**AGENDA
TECHNICAL REVIEW COMMITTEE
REGULAR MEETING
FEBRUARY 23, 2023
10:00 AM
CITY HALL COMMISSION CHAMBERS
204 ASH STREET
FERNANDINA BEACH, FL 32034**

Applicant Name: Matthew Phillips
Project Description: COA Memorial Park
Location: 1901 Island Walk Way
TRC Case Number: TRC 2023-0030

1ST ROUND REVIEW COMMENTS:

DRAWING NO.

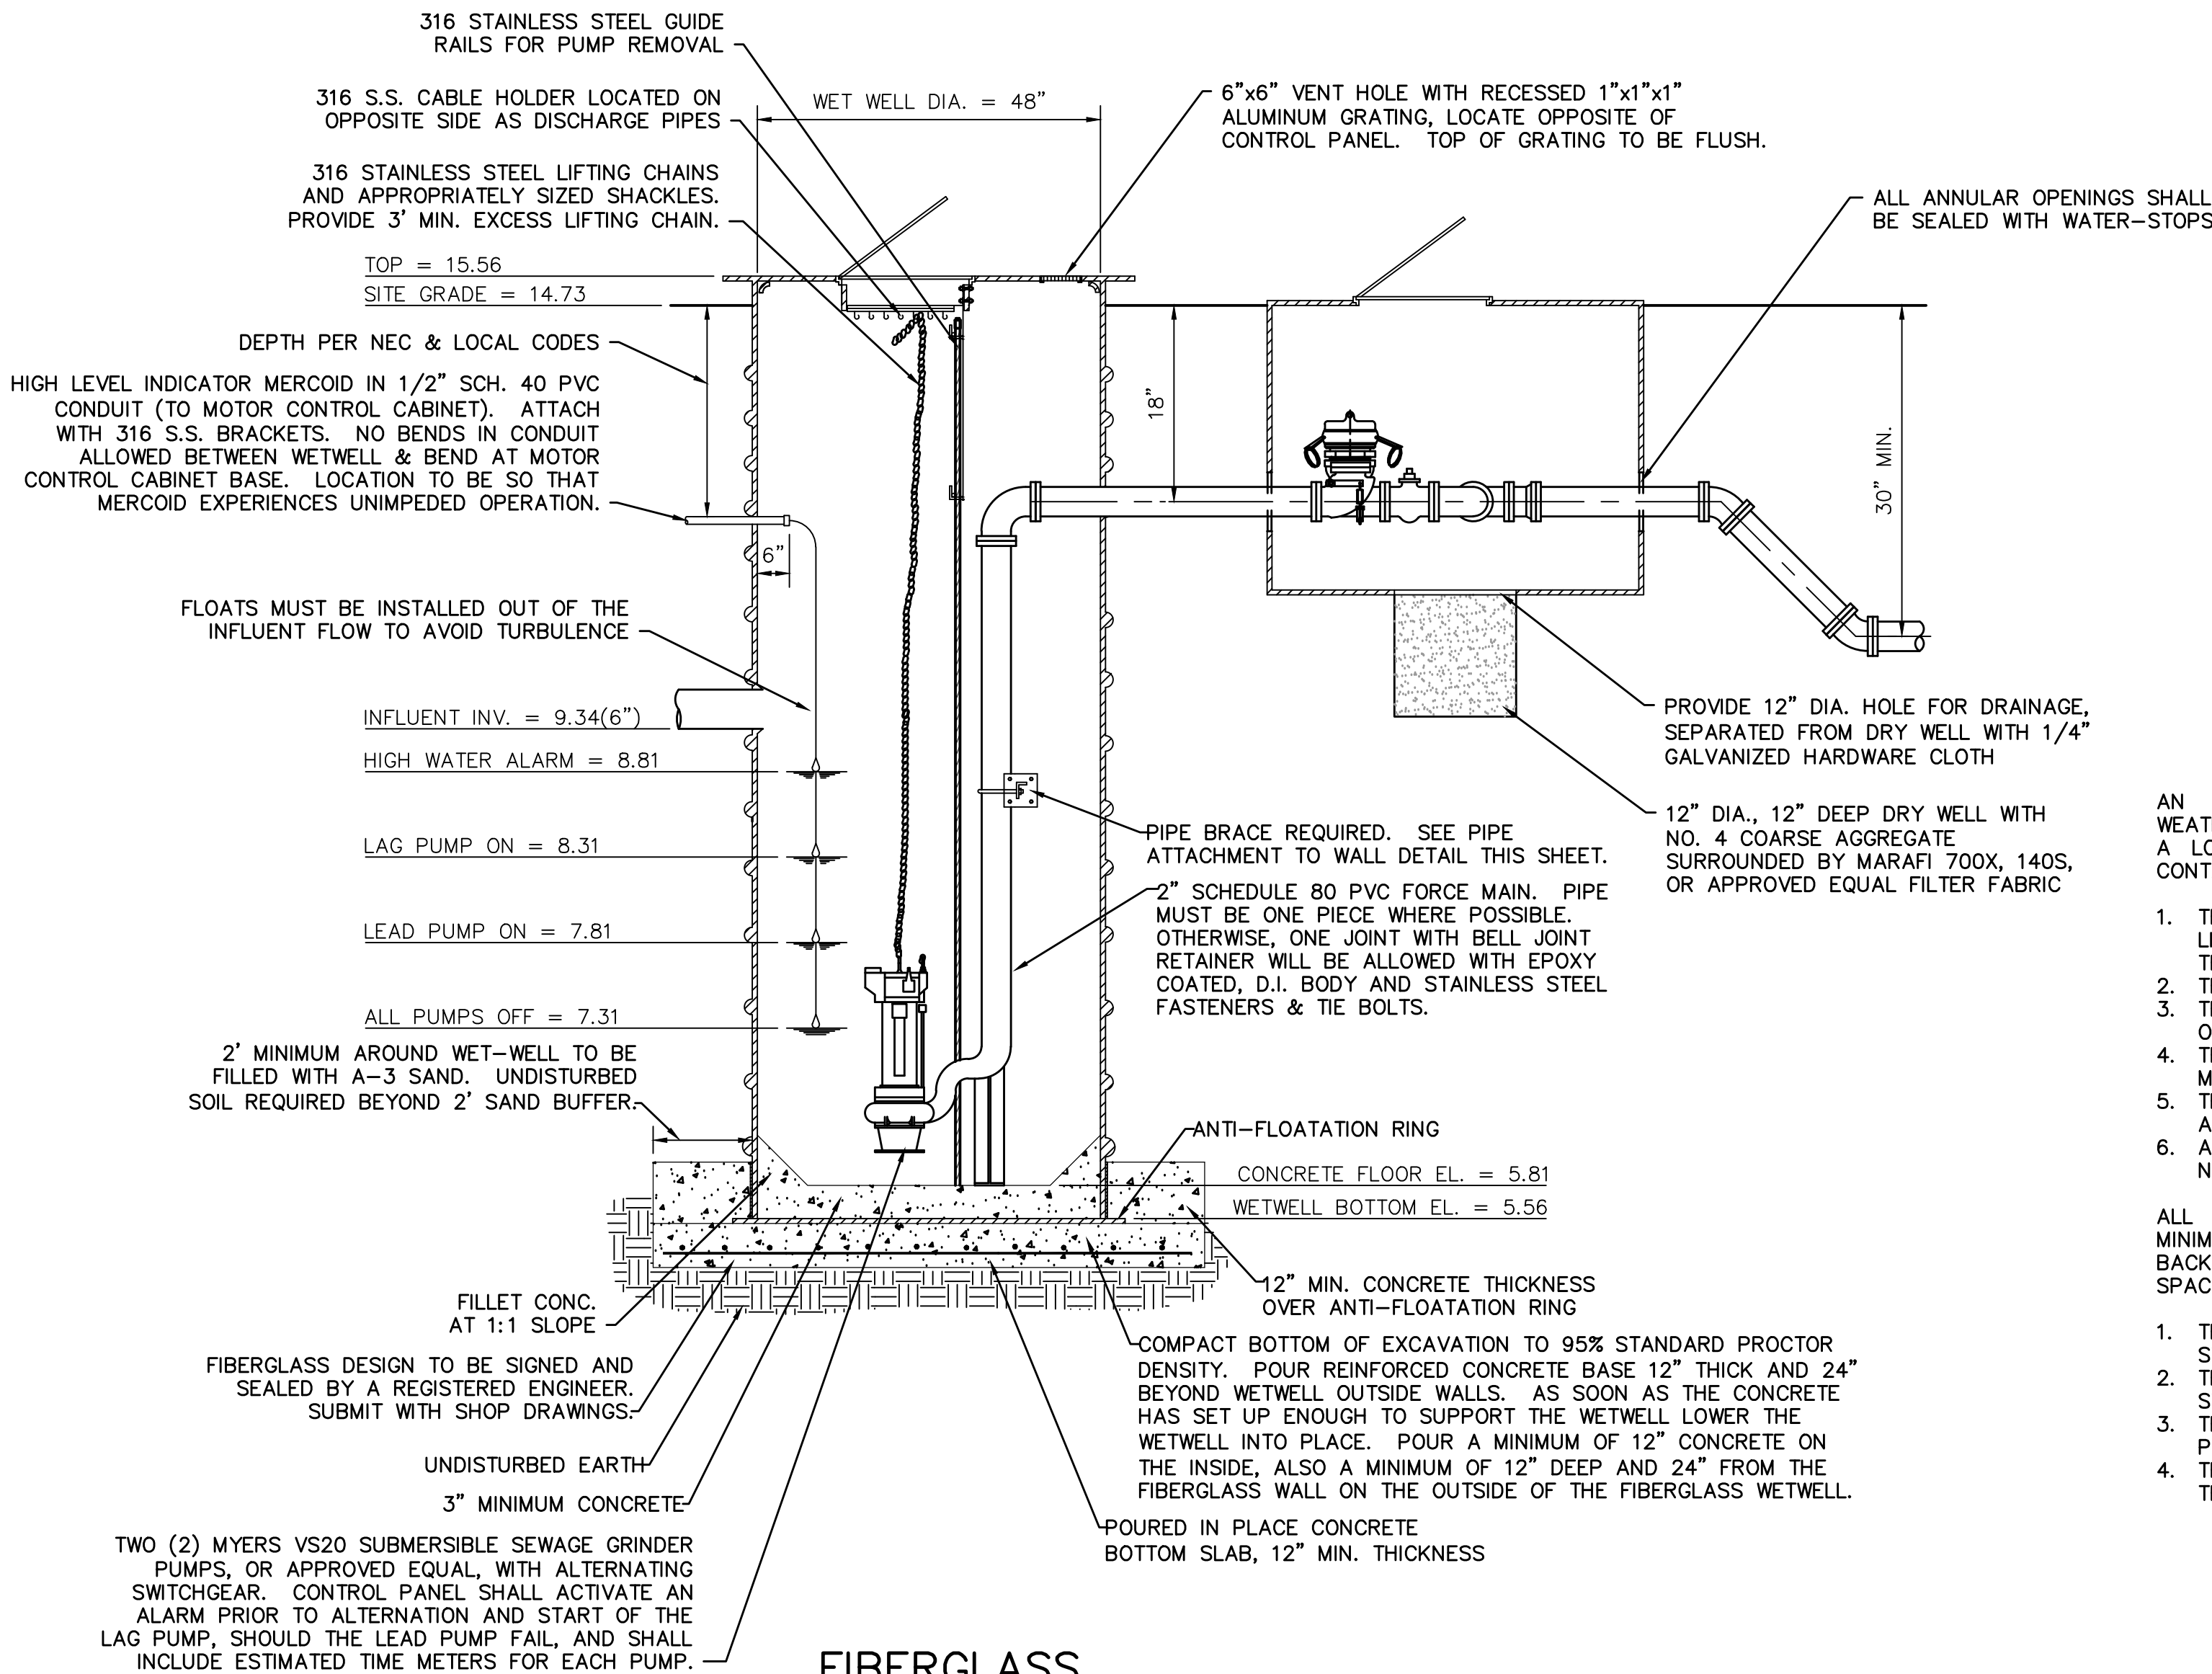
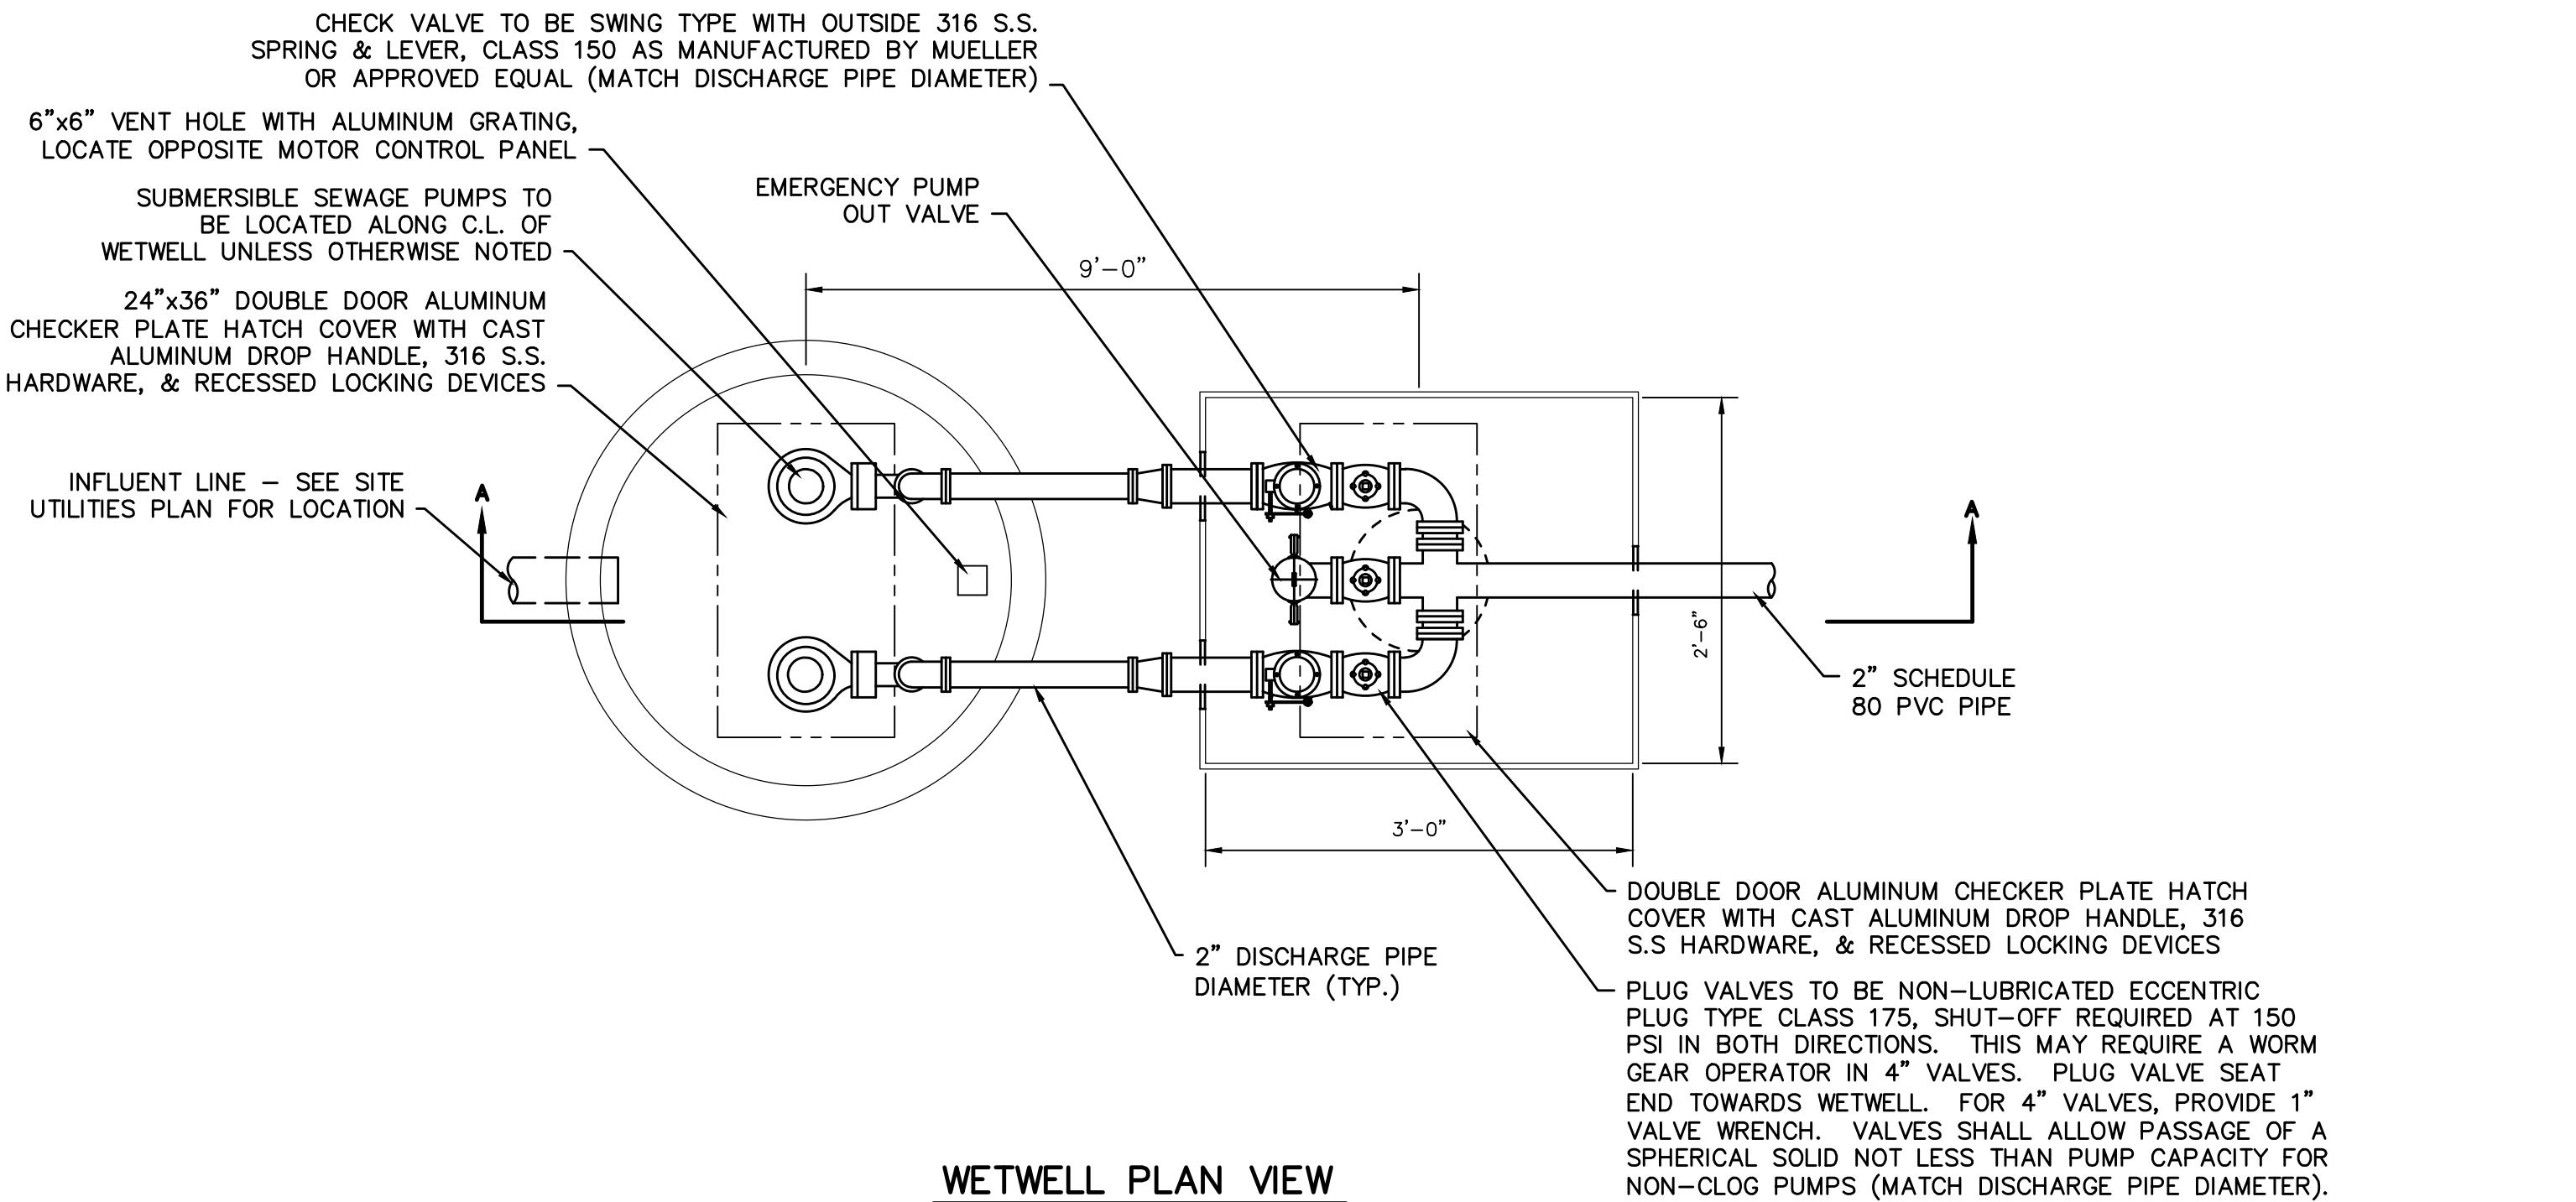
- Please provide on a sign by the Lift Station the number to call in case of an emergency.
- The valve box needs to be completely sealed in to prevent any drainage in case of a leak. Plumb it back to the wetwell with a p-trap to prevent gas build up as well.
